# SAS-2 S-Parameters of Cable Assemblies and Backplanes (08-187r1)

Barry Olawsky  
Hewlett Packard  
(6/12/2008)

# Cable Assembly Data

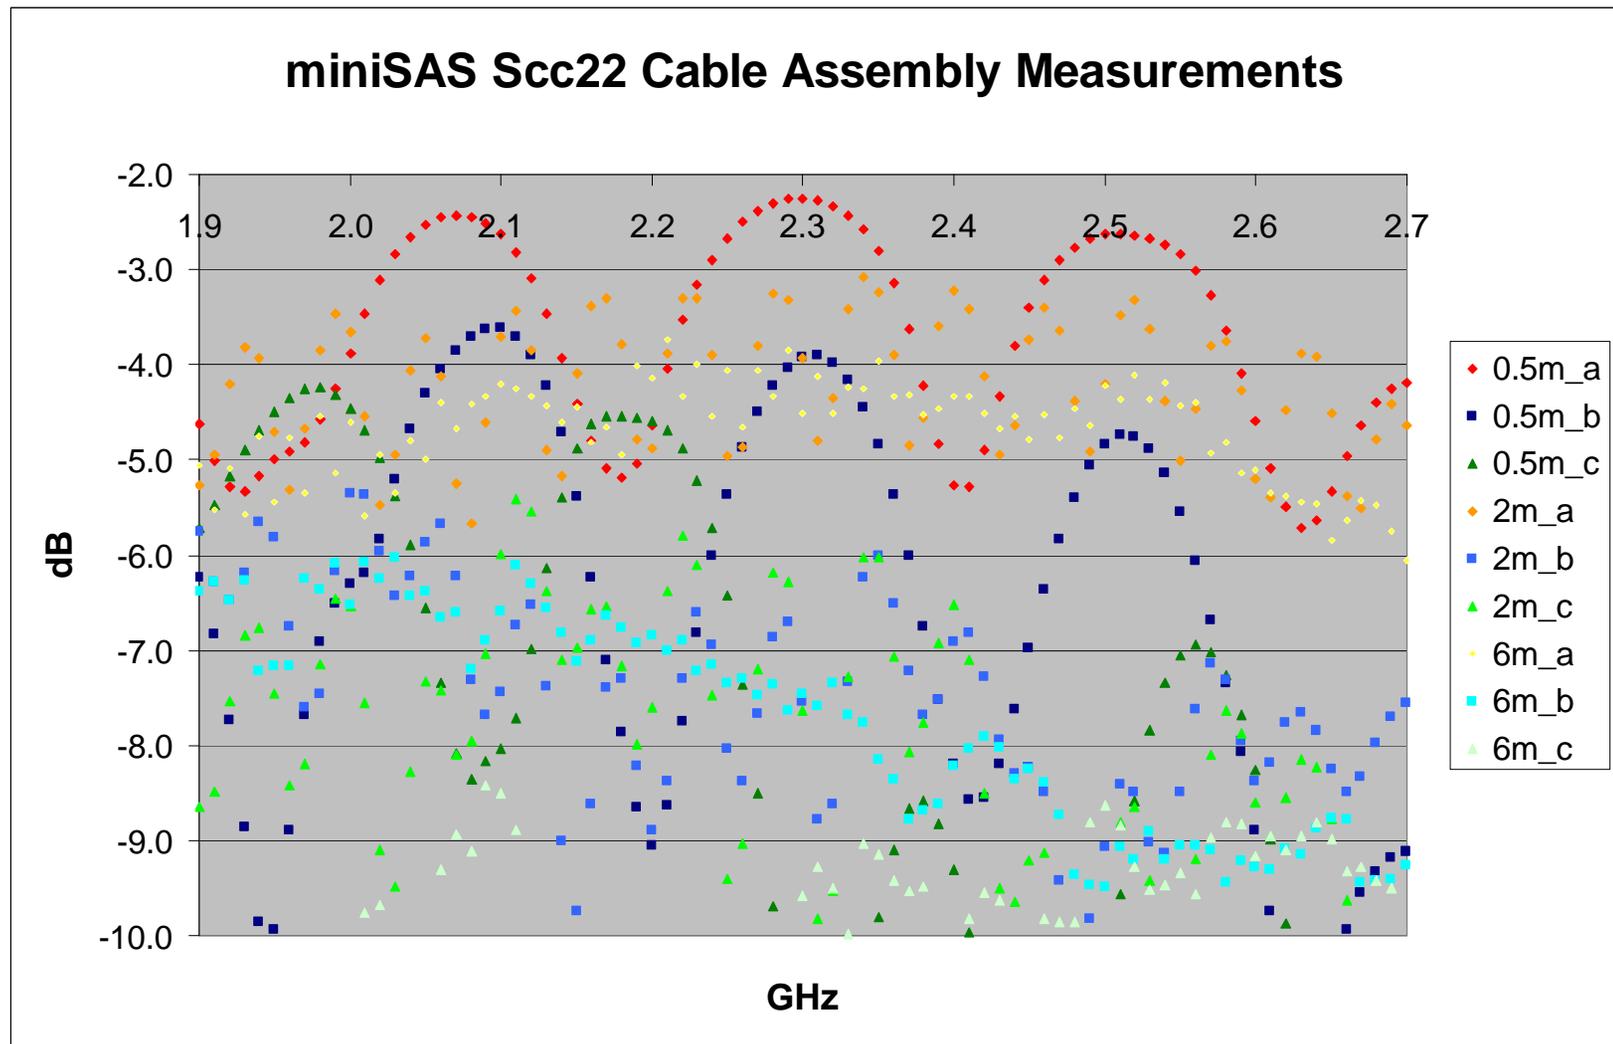
# Cable Assembly Data Notes

- Samples consisting of three cable lengths from three different suppliers were measured
- Fixturing was not de-embedded but the test board traces maintained a well controlled 25-ohm common mode impedance up to the miniSAS connector footprint
- The miniSAS connector/cable interface has at least three unique coupled regions with each one yielding a unique common mode impedance ... PBC mounted connector, paddle card and bulk cable

# Common Mode Impedance Variations in Board Design

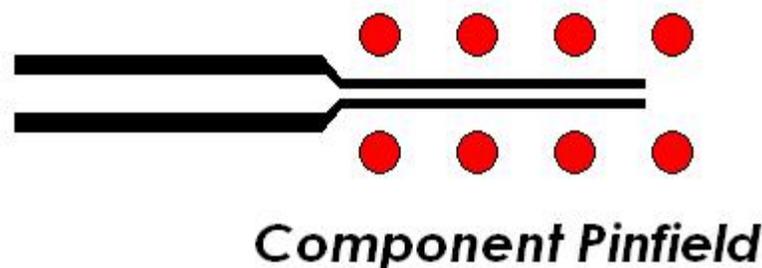
- Trace structure variation is a common layout practice
- Trace width and spacing are varied in order to access all points in connector and BGA pinfields
- Differential impedance is maintained while common mode impedance variations are tolerated

# Multiple Impedance Discontinuities

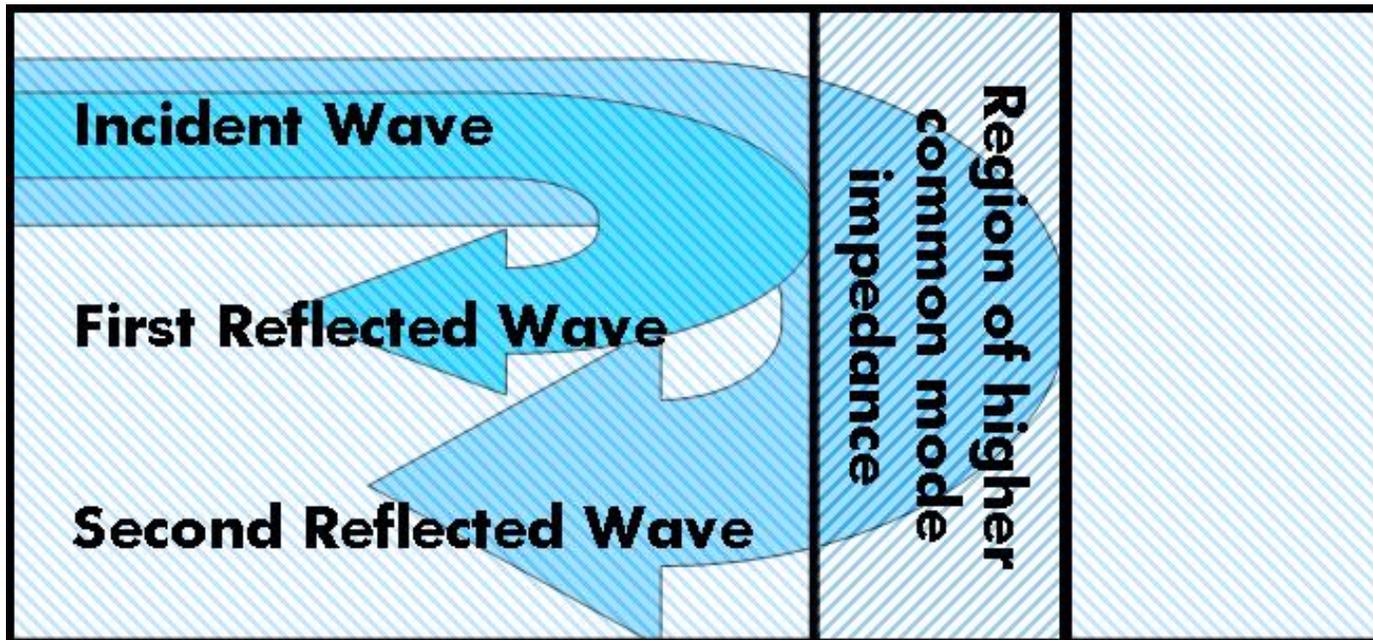
- Each change in common mode impedance will introduce a wave back to the compliance point. Multiple changes between 25 and 40 ohms will result in a return loss greater than -12.7dB at specific frequency points

# Potential Scd22 Issues

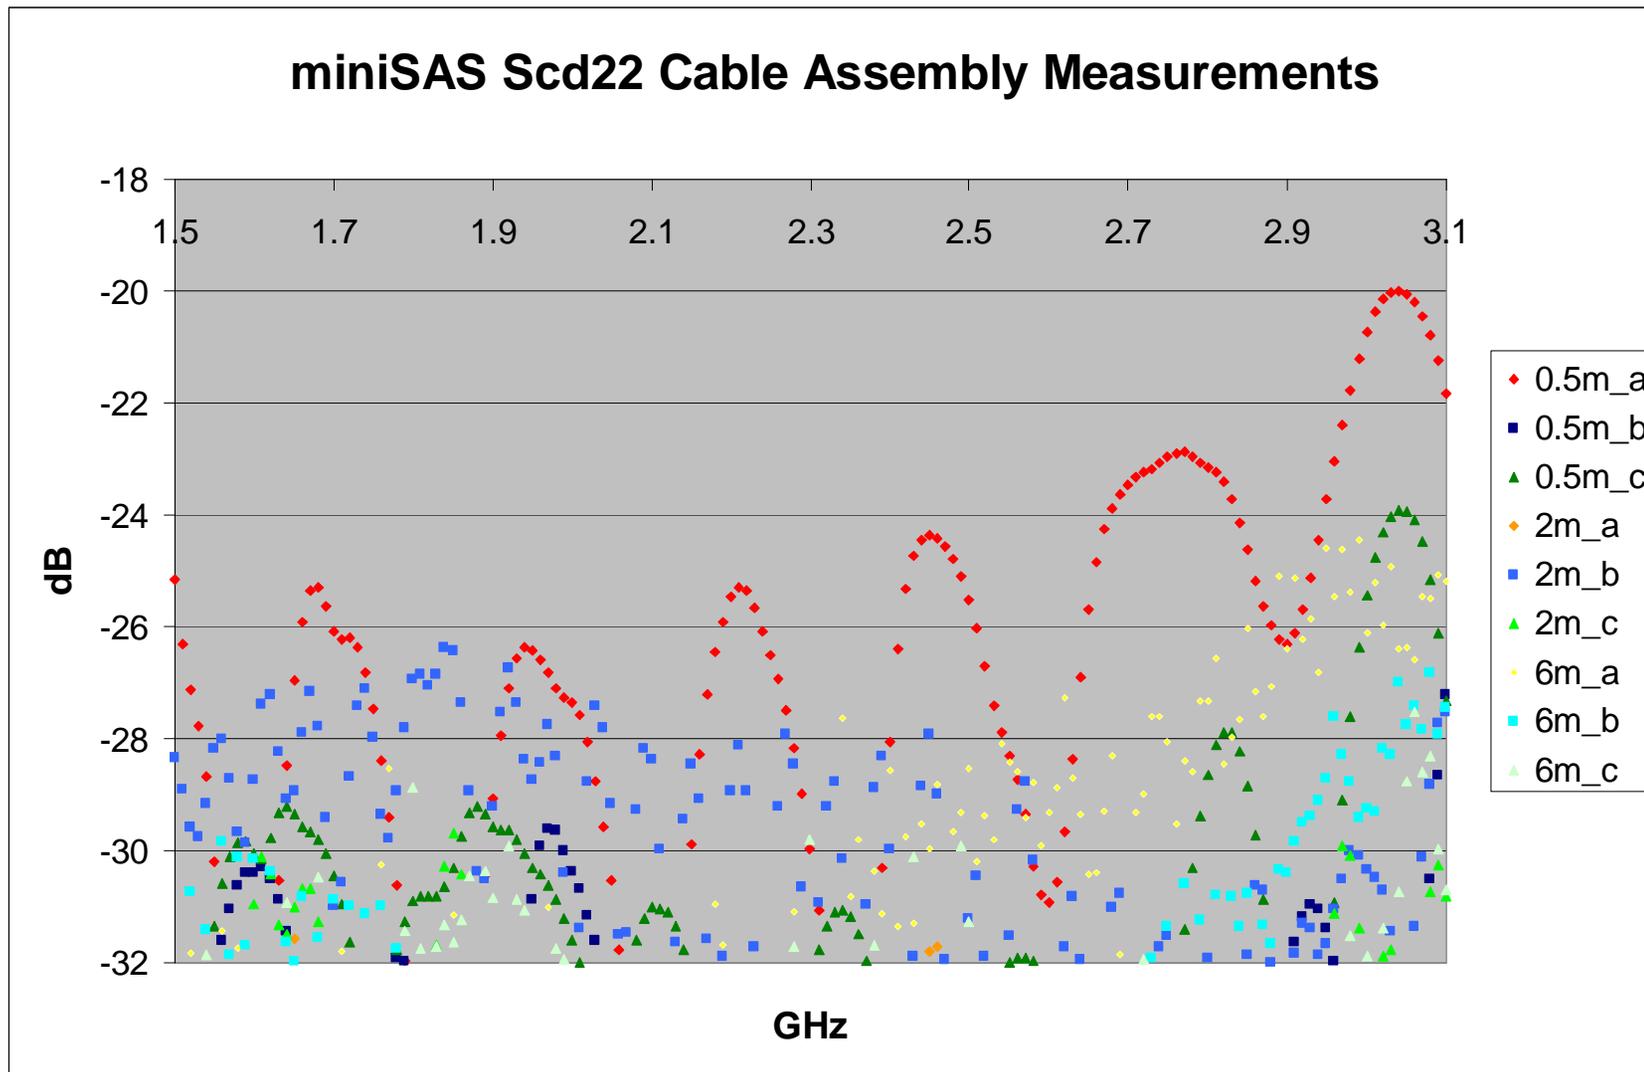
- Imperfect twin-axial cable termination is very common. Any imbalance introduced during the assembly process can result in non-ideal mode conversion parameters (all  $S_{CD}$  and  $S_{DC}$  terms).

Figure 97 — S-parameter values

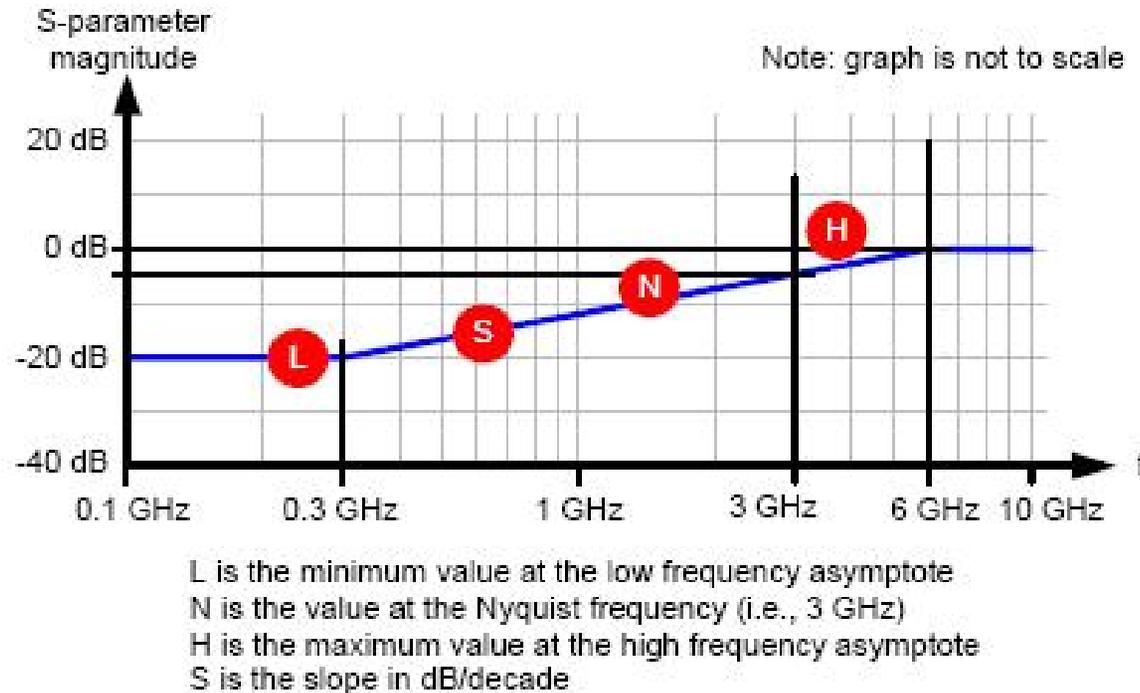
Add figure 97 to section 5.2.7

Figure 97 shows the S-parameter values.

Figure 98 — **cable assembly and backplane**  $S_{DD22}$ ,  $S_{CD21}$  and  $S_{CD22}$  limits.

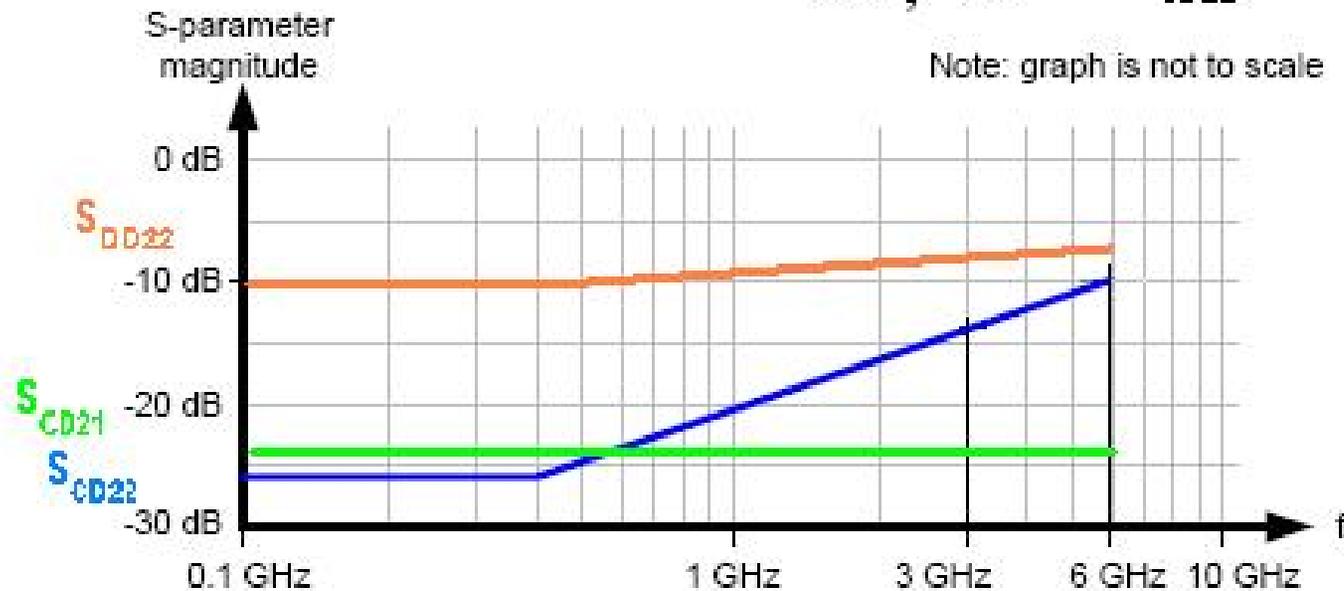
- After discussion of the herein, the group agreed to removal of the  $S_{CC22}$  row from table 51.
- Additionally, the point was made that references made in table 51 to figures 125 and 126 of the transmitter section may be confusing the reader. The group decided to redirect those references to one or more new figures of  $S_{DD22}$ ,  $S_{CD22}$ ,  $S_{CD21}$  located right after table 51.

Add figure 98 to section 5.2.7

Figure 98 shows the **cable assembly and backplane**  $S_{DD22}$ ,  $S_{CD21}$  and  $S_{CD22}$  limits.
